ADDENDUM NO. 1

DENNIS-HARWICH
Federal Aid Project No. STP/CMQ/TAP/CRP-0035(066)X
Reconstruction & Related Work on Main Street (Route 28),
from Upper County Road to the Herring River Bridge

QUESTIONS AND RESPONSES

PLAN SHEET REVISIONS

MANHOLE 6' X 12' X 7'

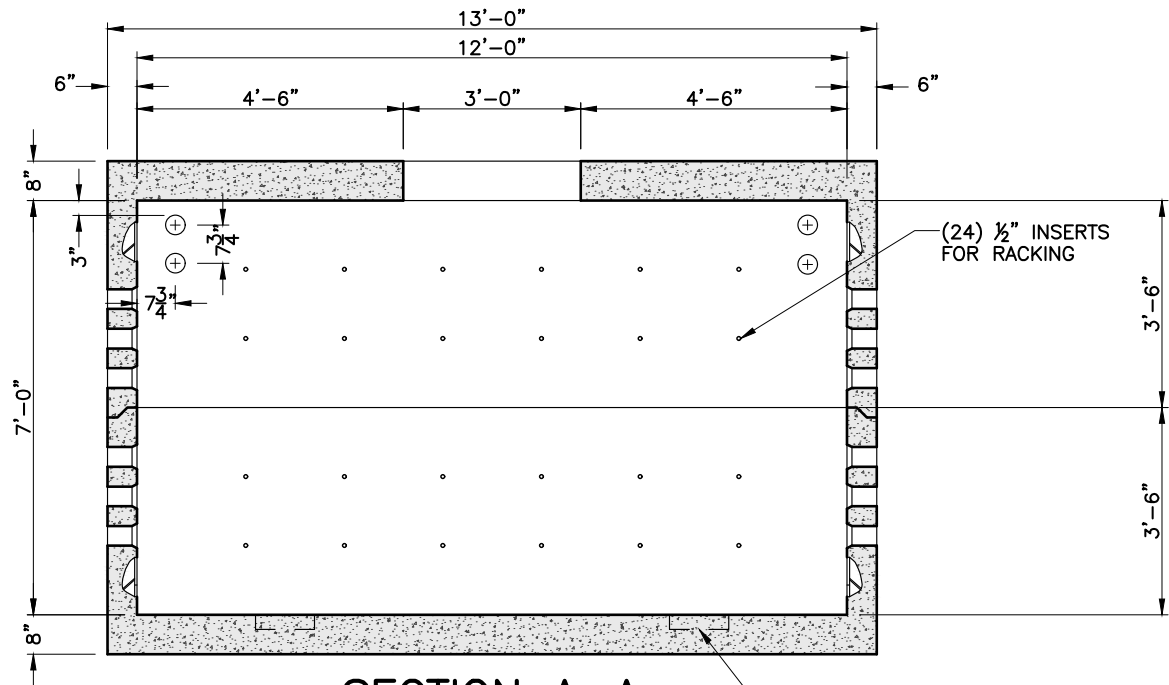
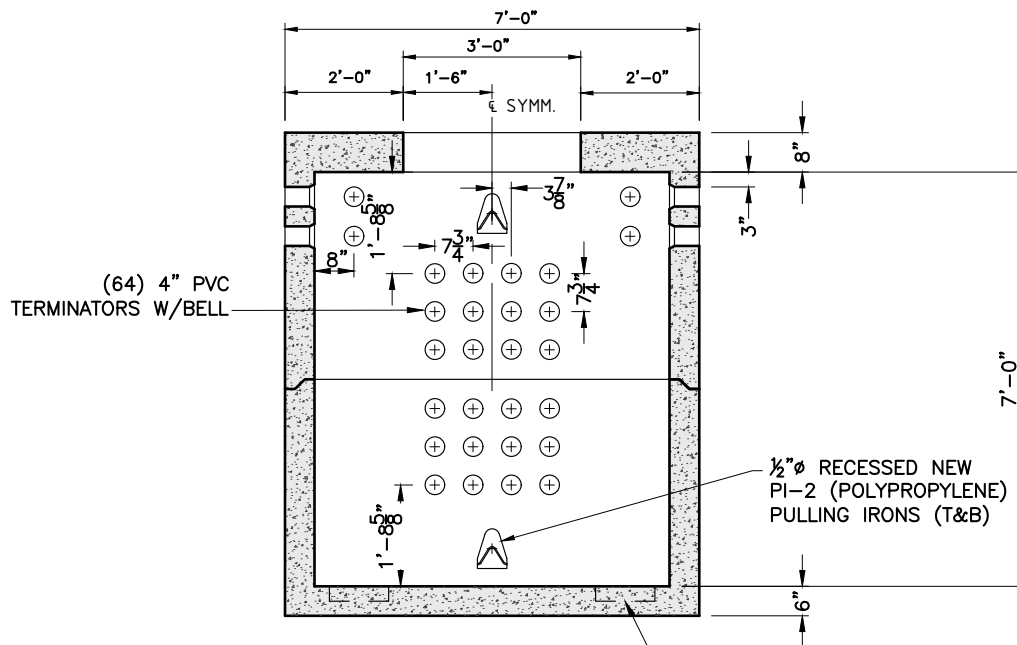
Bid Item 811.121 TELEPHONE MANHOLE (3EA). Can MassDOT please confirm that the proposed precast telephone manhole that we should price is a:

Verizon Manhole with Inside Dimensions: 6'Wx12'Lx7'H as shown on the attached drawing. There is no detail in the bid documents that clearly identifies and or specifies the dimensions of the telephone manhole.

See revised pages A00809-3 & 4 issued via this addendum.

STATE	FED. AID PROJ. NO.	SHEET NO.	TOTAL SHEETS
MA	STP/CMQ/TAP/CRP-0035(066)X	6	105
PROJECT FILE NO.		608742

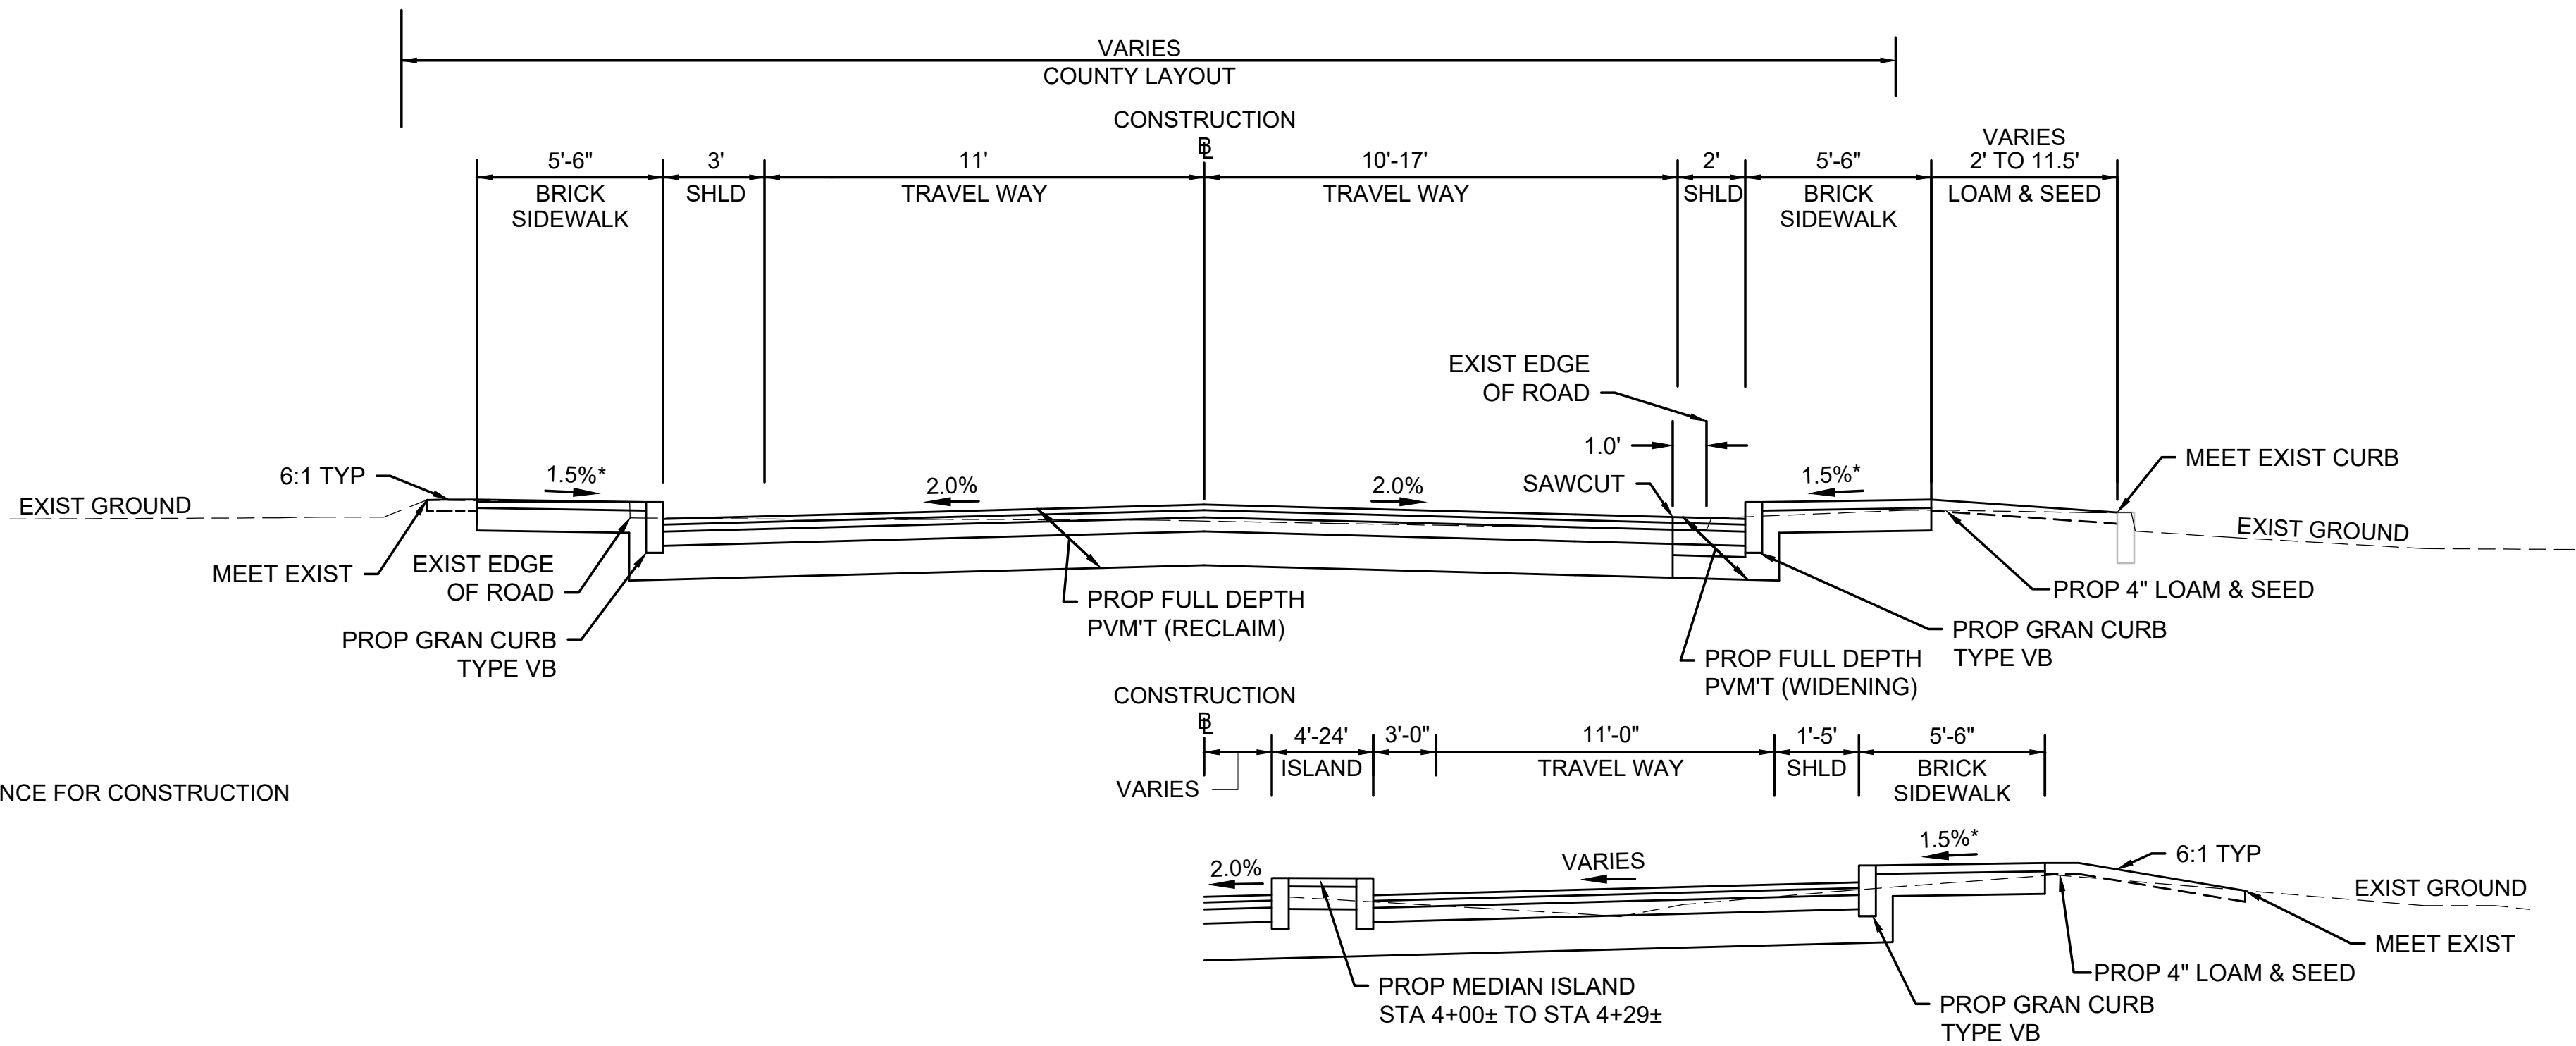
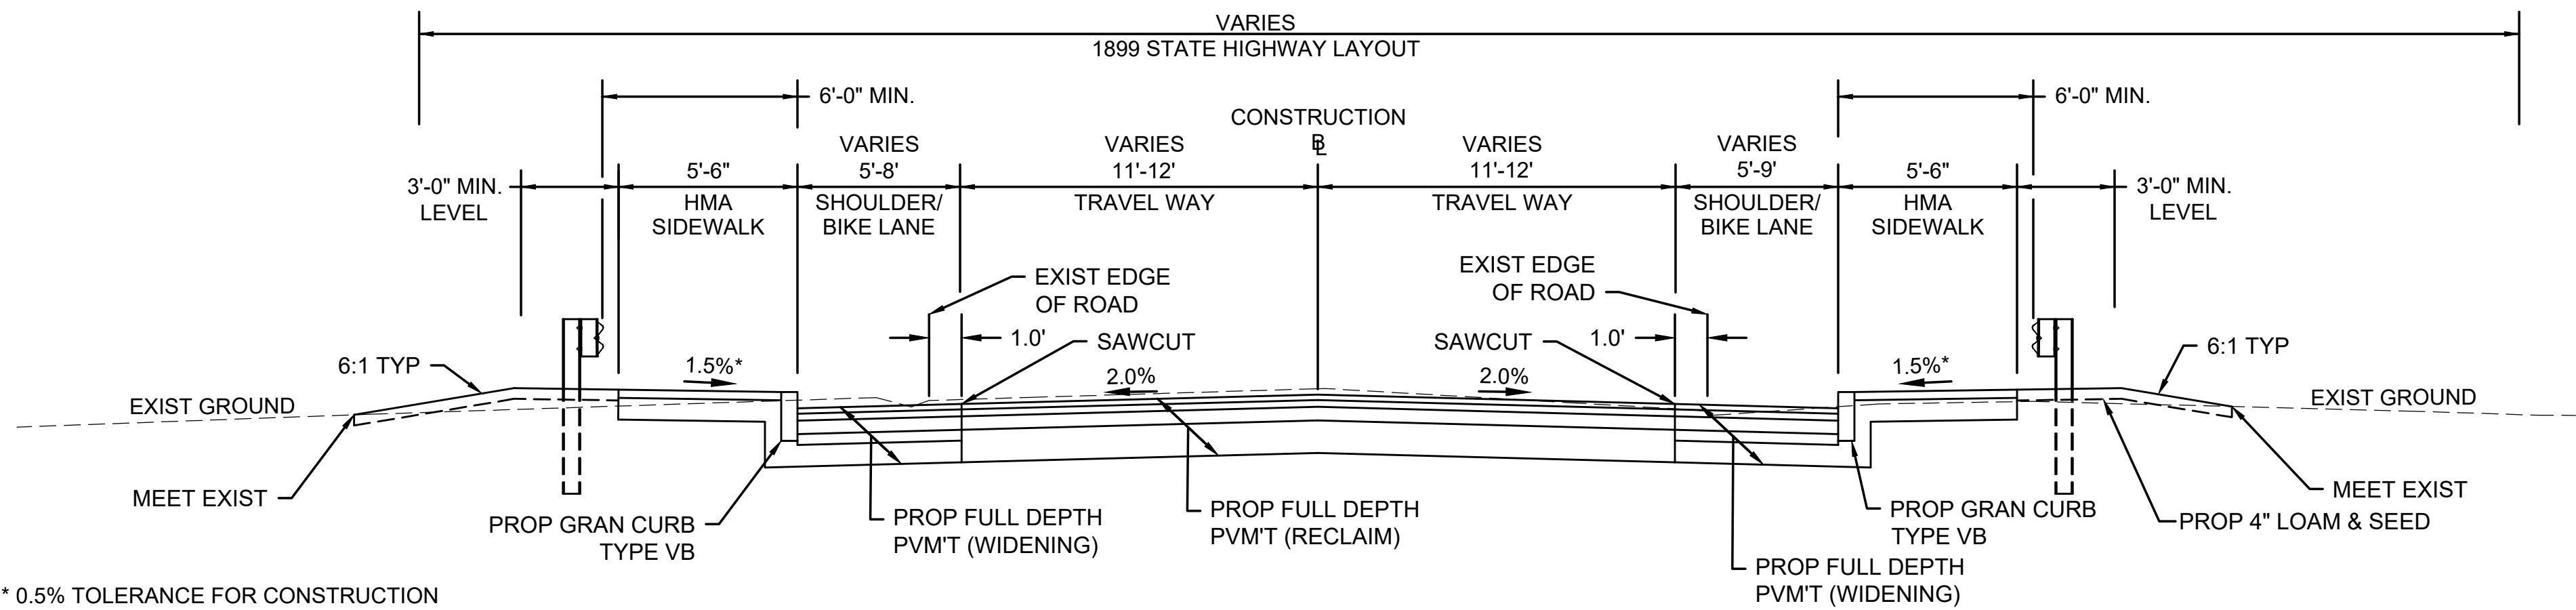
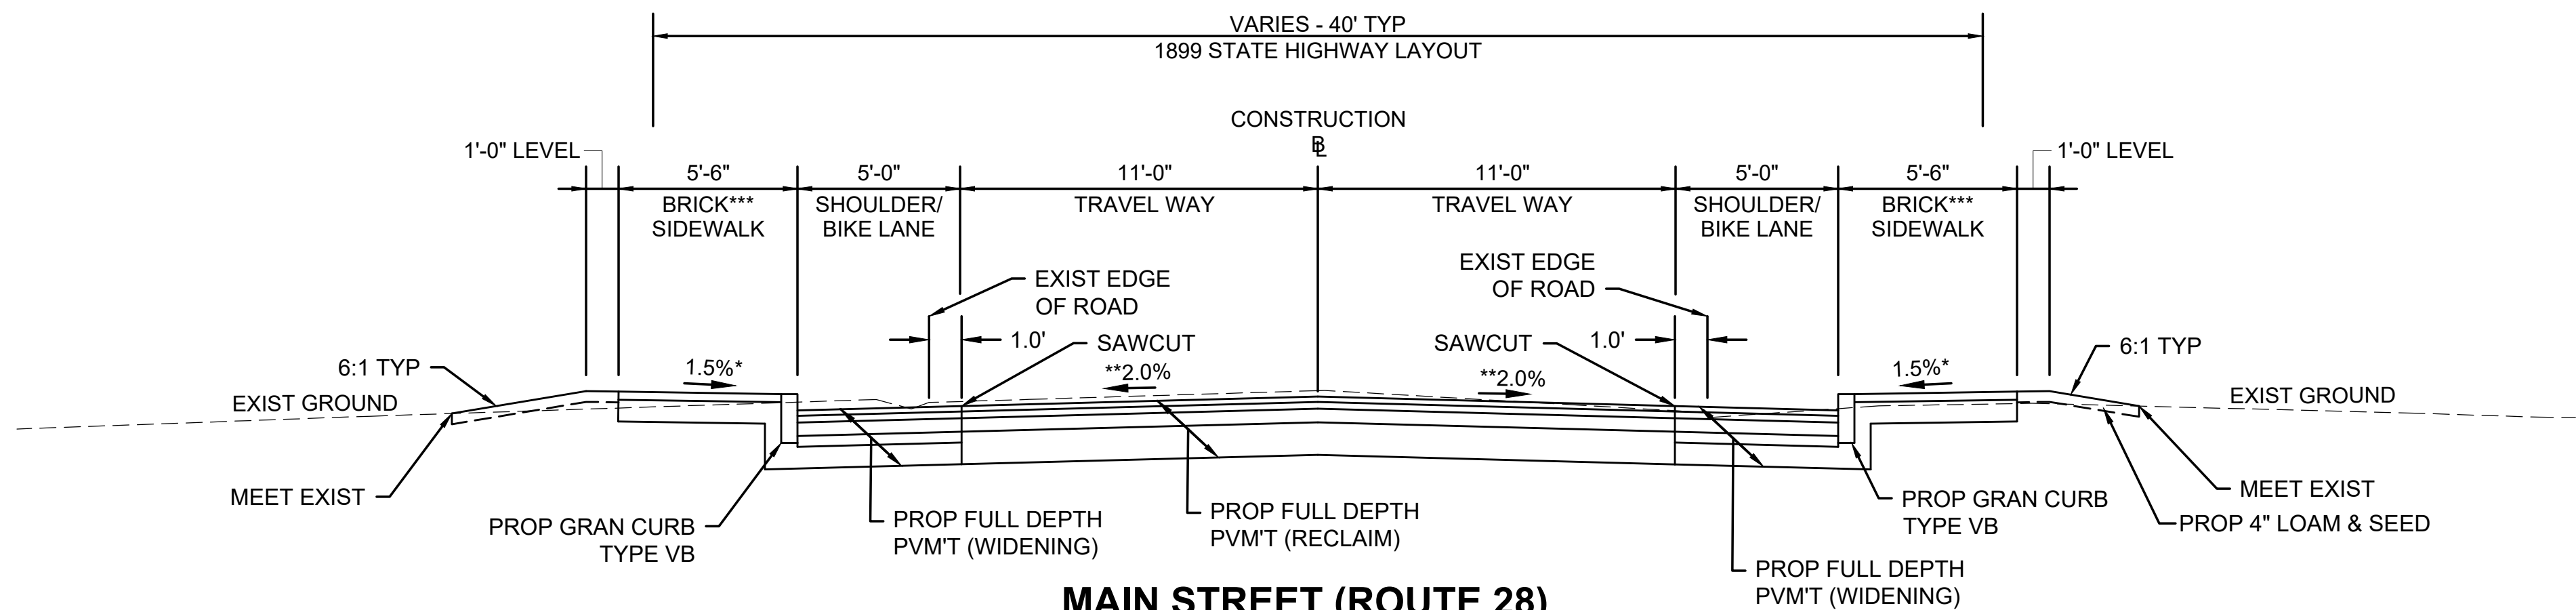
The specifications state reclaiming is to be at a depth of 15". The asphalt cores taken on the existing roadway show pavement depths of 8.5 – 13.5". Since the intent of the contract is to produce an acceptable base through reclamation, please clarify how we are to proceed with a mixture that will be 57% - 90% asphalt and very little of the existing gravel base in the mixture? This will ultimately not produce a usable gravel product.

The 15" reclaim depth is a minimum and the depth may be set deeper in coordination with the Engineer, as noted in the special provision for Item 403.2. See revised pages A00801-82, 86 and 87 and Plan Sheet 6 of 105 issued via this addendum.
